RECEIPT DATE: 8/15/22 **ONSITE SEWAGE DISPOSAL SYSTEM** P 572140
 APPROVAL DATE: 12/15/2022 JCC **PERMIT: CONSTRUCTION** A _____
 PROPERTY ADDRESS: 1853 DAVIS BRANCH ROAD, WOODSTOCK, MD 21163
 SUBDIVISION: MYRTUE PROPERTY LOT: 13 TAX ID: 03-352455
 CONTRACTOR: FARM AND HOME EXCAVATING, INC. EMAIL: farmhomeex@verizon.net
 CONTRACTOR ADDRESS: 901 DRIVER ROAD, MARRIOTTSVILLE, MD 21104 PHONE: (410)442-2139
 PROPERTY OWNER: SONSHINE MD LP EMAIL: nbontempi@keystonecustomhomes
 OWNER ADDRESS: 227 GRANITE RUN ROAD, LANCASTER, PA 17601 PHONE: (717)469-9060
 SEPTIC TANK SIZE (GALLONS): 2000 TANK MANUFACTURER: MAYER BROS., INC.
 PUMP MODEL: n.a. PUMP SIZE n.a. PUMP TANK CAPACITY: n.a.

PROJECT:	MYRTUE PROPERTY LOT 13		
LOCATION:	TAX MAP: 10, GRID: 24, PARCEL: 225, ZONED: RC-DEO 1853 DAVIS BRANCH RD. WOODSTOCK, MD 21163 6TH ELECTION DISTRICT, HOWARD COUNTY, MD, TAX ID 352455		
TITLE:	ONSITE SEWAGE DISPOSAL PLAN		
HOUSE TYPE:	CUSTOM - KEYSTONE HOMES		
DATE:	NOVEMBER, 2021	PROJECT NO.	2099
SCALE:	AS SHOWN	DRAWING	2 OF 2

PROJECT: MYRTUE PROPERTY LOT 13	
LOCATION: TAX MAP: 10, GRID: 24, PARCEL: 225, ZONED: RC-DEO 1853 DAVIS BRANCH RD. WOODSTOCK, MD 21163 6TH ELECTION DISTRICT, HOWARD COUNTY, MD.

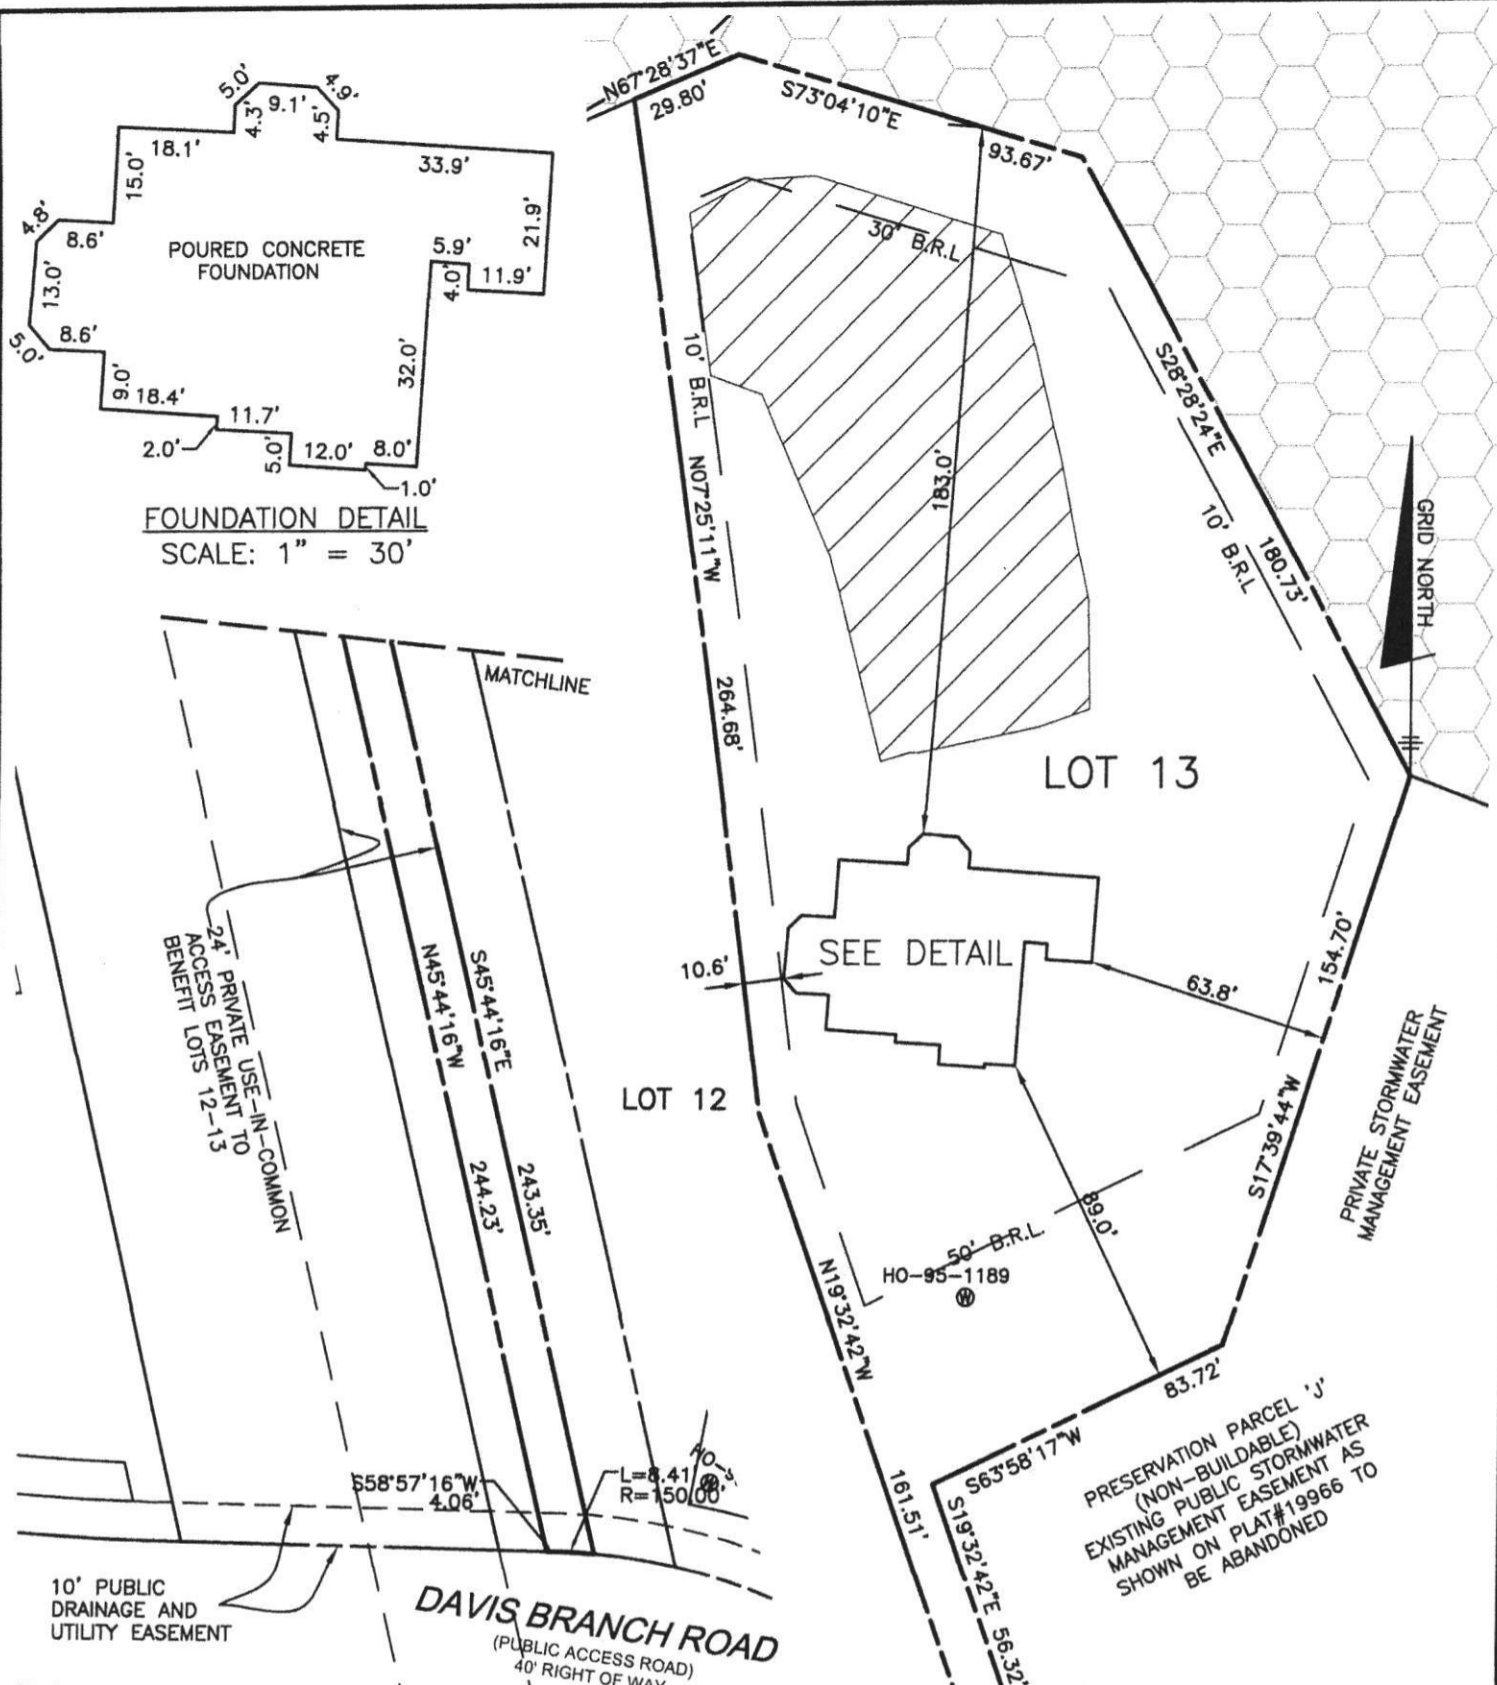
12/5/22 - builder has dirt pile on T_{1,3} area. pile. SDA is staked. sewer line under foundation confirmed septic tank & T_{1,3} id out. T₁ is 50. Trenches was staked by builder, not surveyor (RR/SP)

INSTALLATION: Plumber came out 12" below planned elevation, caused tank lid depth to be 2.5' - 3.5' below grade. Saw front baffle. Tank level. (RR/SP)

12/13/2022 - phone convo w/ contractor stating T₁ inlet is already at 8' (RR/SP)

12/19/2022 TRENCHES COMPLETE; D BOX LEVELED W/ SPEED LEVELS

SEWER OUTFALL LOT 13
 SCALE: 1"=50' HORIZ., 1"=5' VERT.

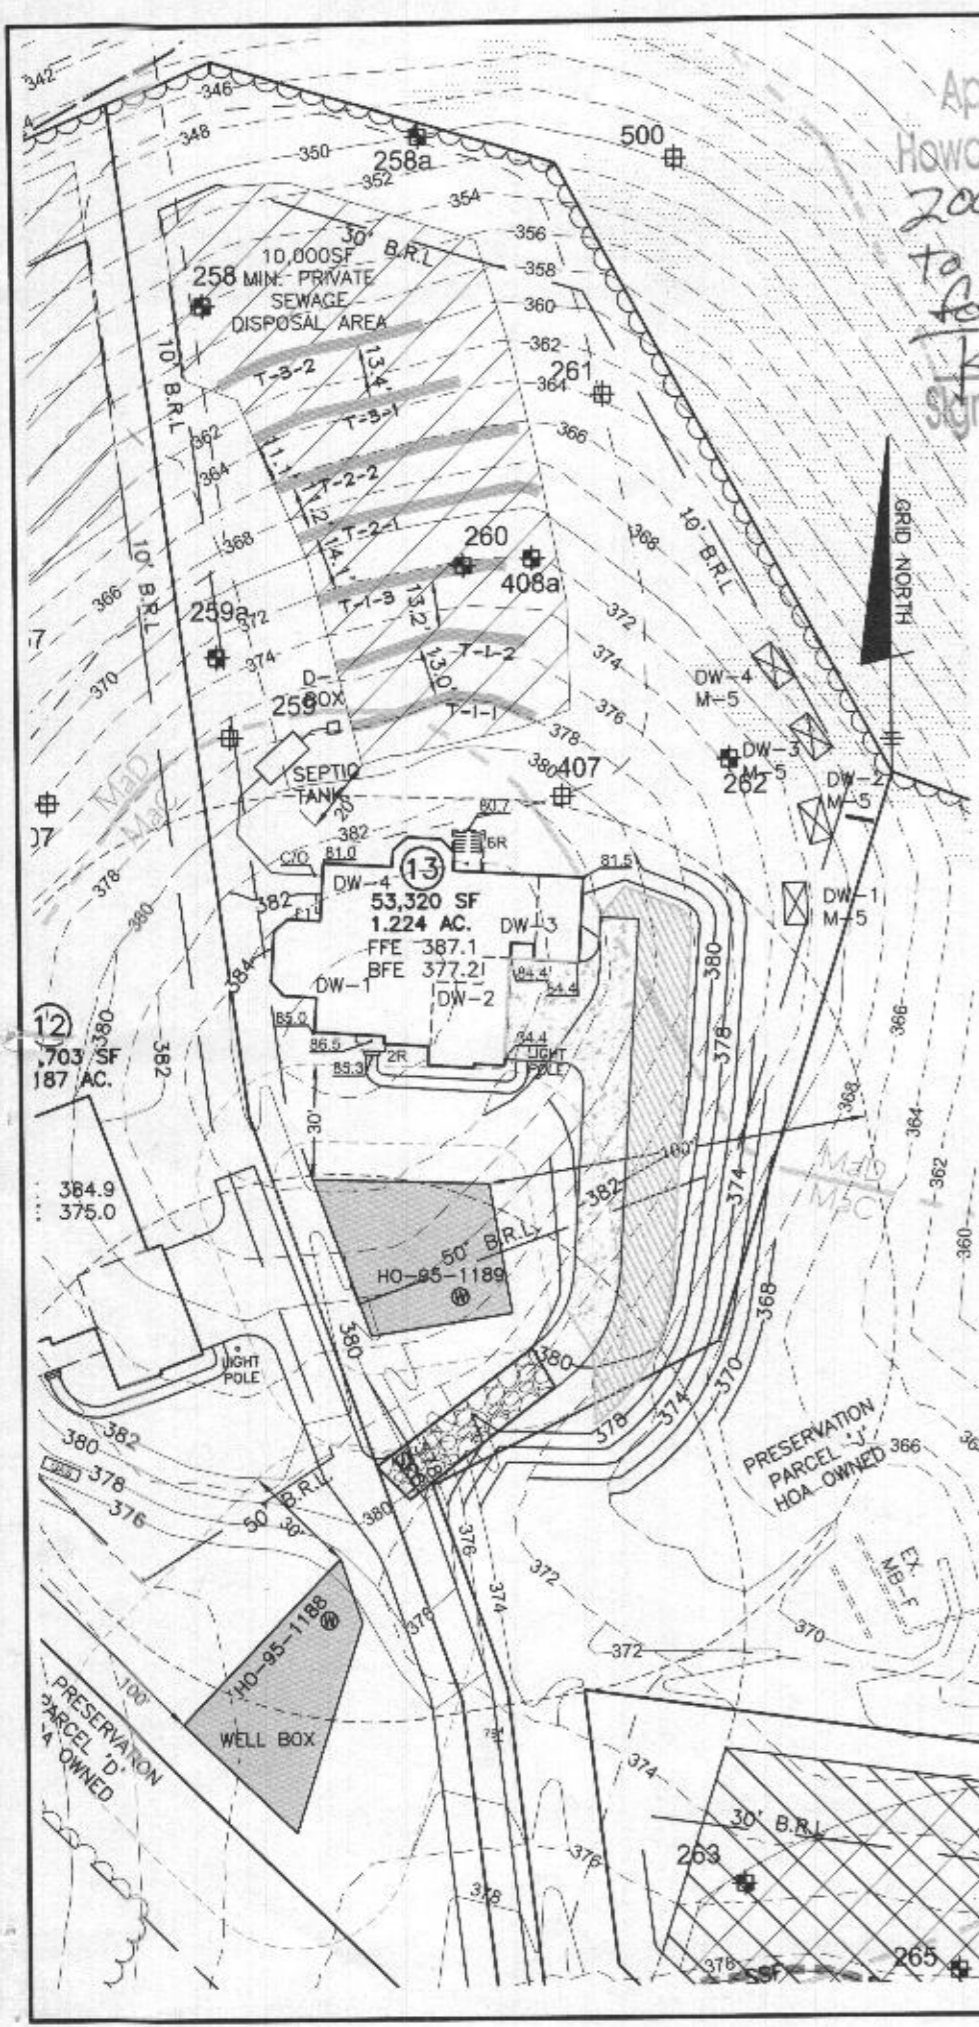
2'
to grade

4'
to
grade

contractor will cut
grade to be 2.5' to 3.6'
cover on tank
